# RENESAS TECHNICAL UPDATE

Product Category	MPU/MCU		Document No.	TN-SY*-A0050A/E	Rev.	1.00
Title	Errata for User's Manual regarding the IIC		Information Category	Technical Notification		
Applicable Product	Renesas Synergy™ S3A3 MCU Group	Lot No.	Reference Document	S3A3 Microcontroller Group User's Manual Rev.1.10		
		All

The specified Renesas Synergy S3A3 User's Manual has incorrect statements about the IIC.

Incorrect Figure

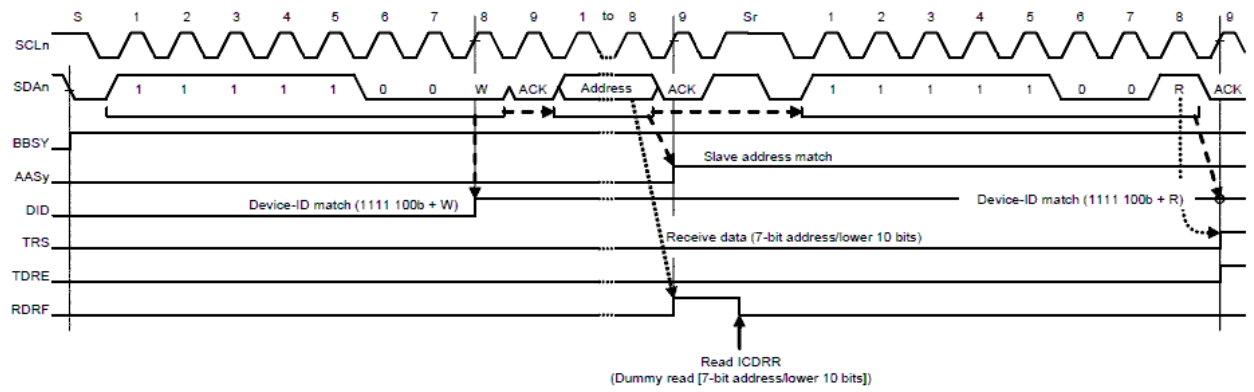
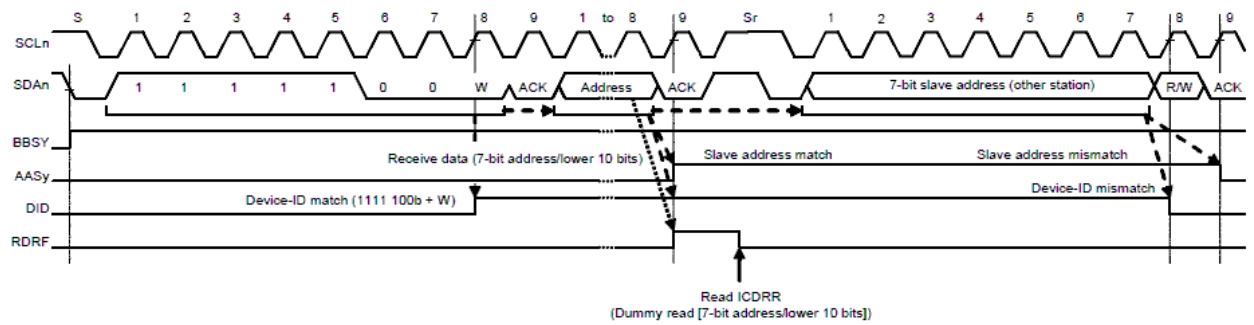
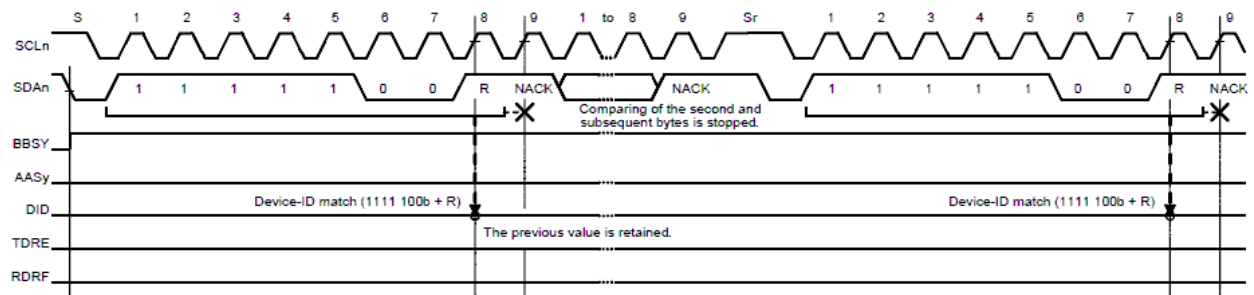
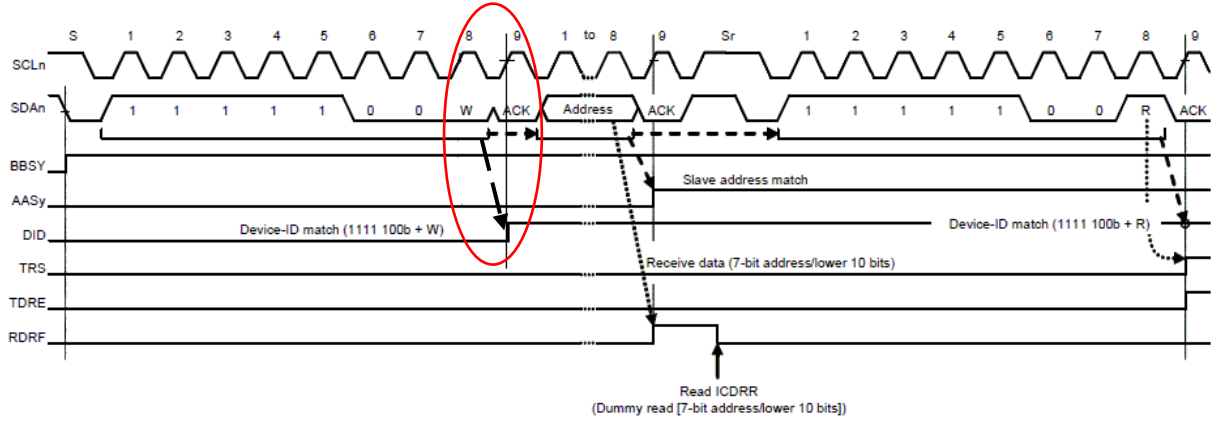
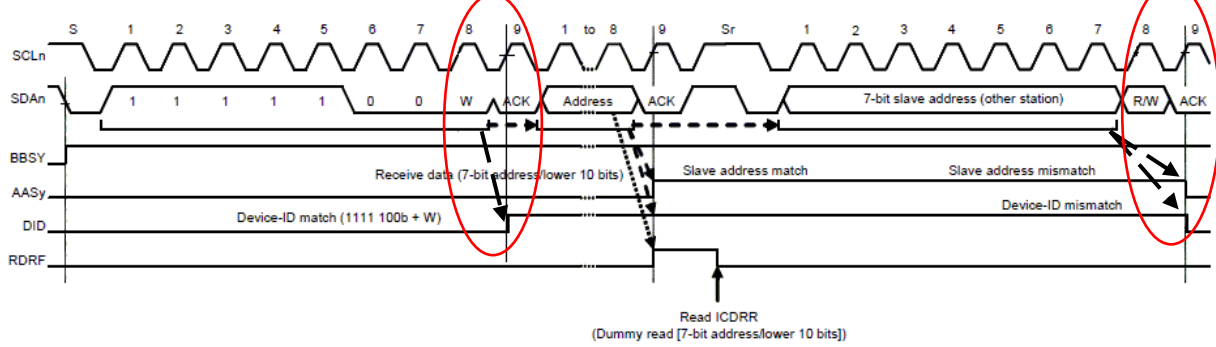
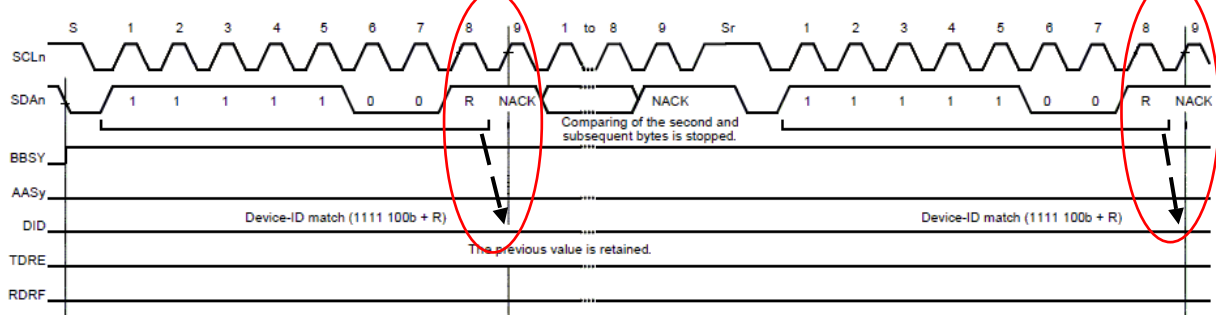
Device-ID reception

When address received after a restart condition is detected does not match the device-ID

When address before the device-ID + R does not match the slave address

Correct Figure

Device-ID reception

When address received after a restart condition is detected does not match the device-ID

When address before the device-ID + R does not match the slave address

Page 938 of 1618

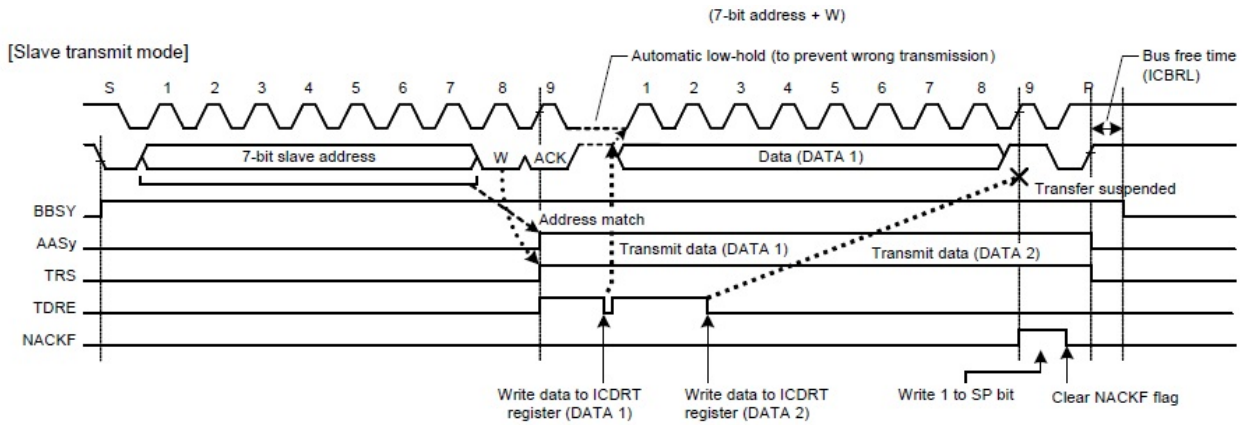
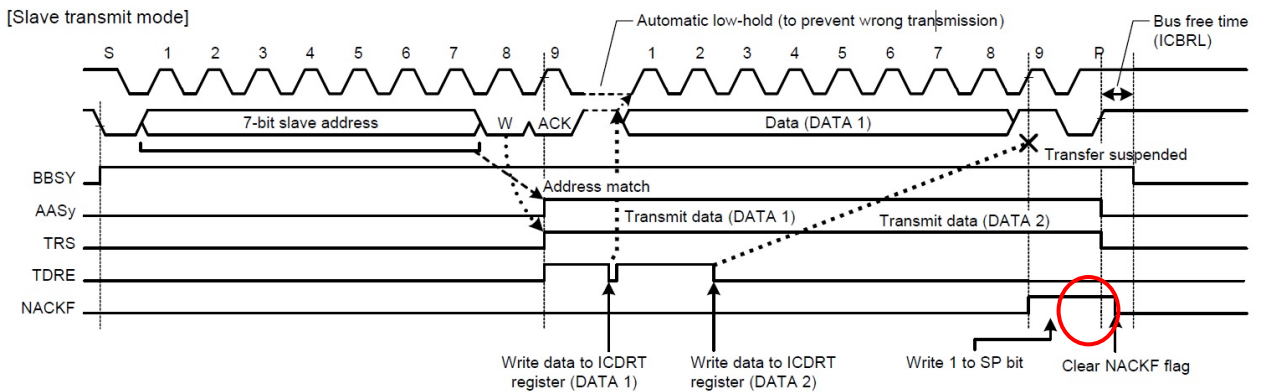
Incorrect Figure

Correct Figure

Page 947 of 1618

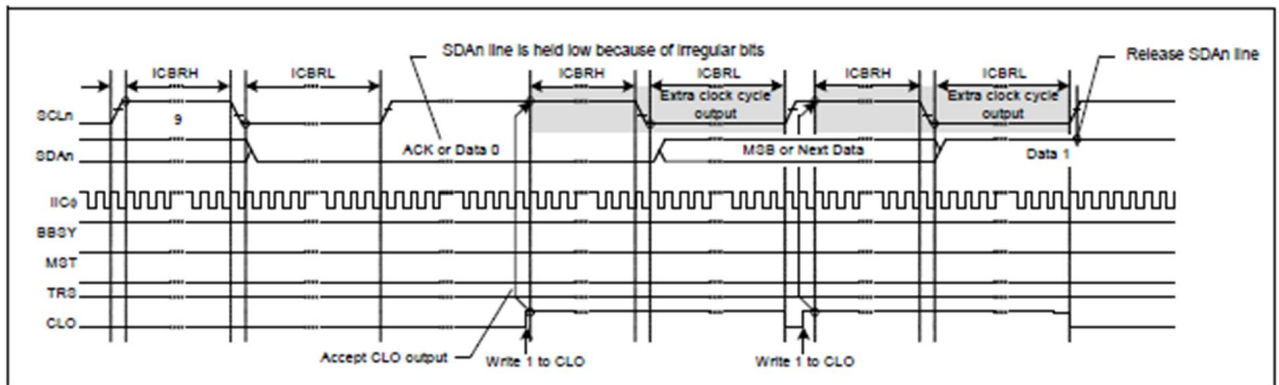
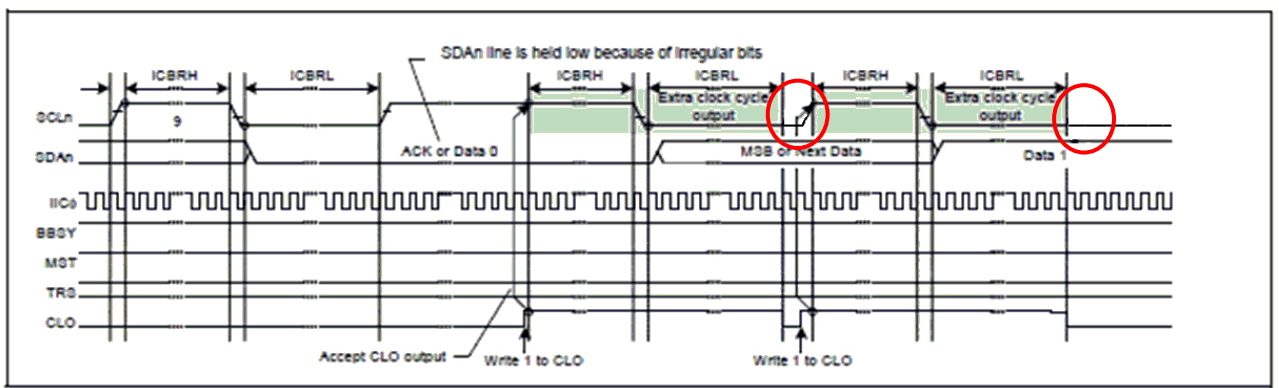
Incorrect Figure

Correct Figure
